MECKLENBURG COUNTY
GROUNDWATER & WASTEWATER SERVICES

APPLICATION FOR A RESIDENTIAL SITE IMPROVEMENT PERMIT/ CONSTRUCTION AUTHORIZATION FOR AN ON-SITE WASTEWATER SYSTEM, NEW WELL INSTALLATION, OR REPAIR OF EXISTING WELL

Blackwood Knoll Soil Evaluation Summary

Re: Application for improvement permit for:
Property Site: 14301 black Farms Road
Health Department file number: **7531B**

Sketch of Soil Evaluation Locations

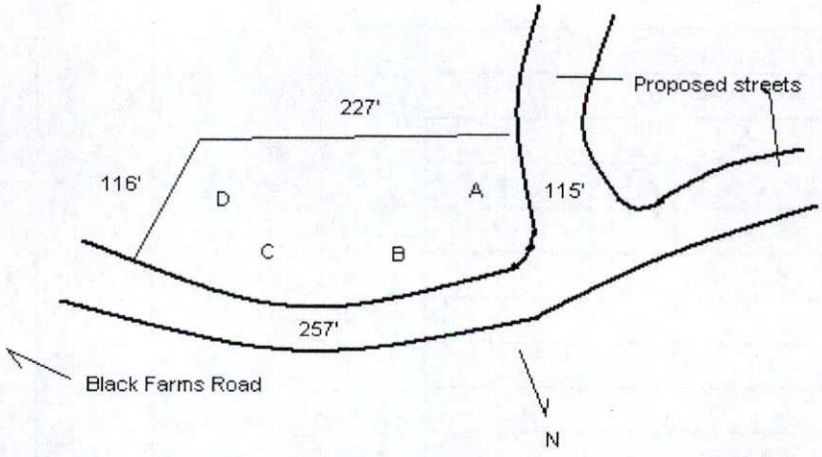
COMMENTS:
100% repair

Sketch of Soil Evaluation Locations

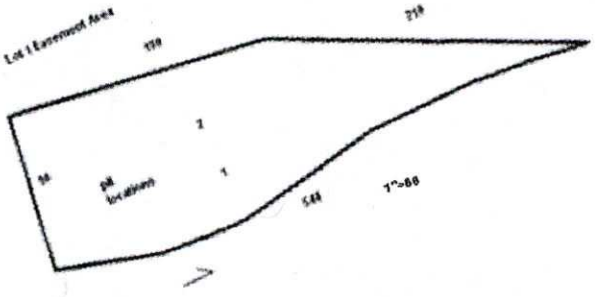
Other Factors (.1946):
Soil Evaluation By: Jason Jackson
Others Present: Jeremy Michelone, Bill Marlin
Site Classification (.1948): Provisionally Suitable
Site Evaluation By:
Others Present:

COMMENTS: 100% REPAIR AREA REQUIRED. FILE #: 7531B

Sketch of Soil Evaluation Locations

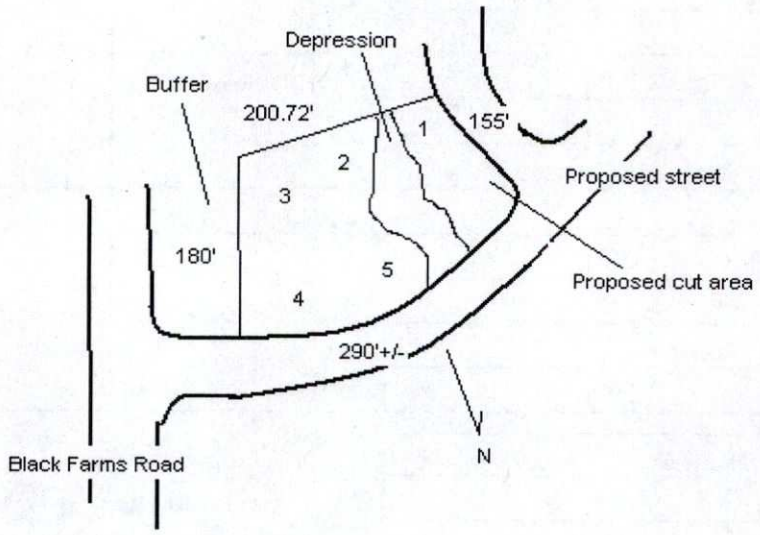
COMMENTS:
100% repair
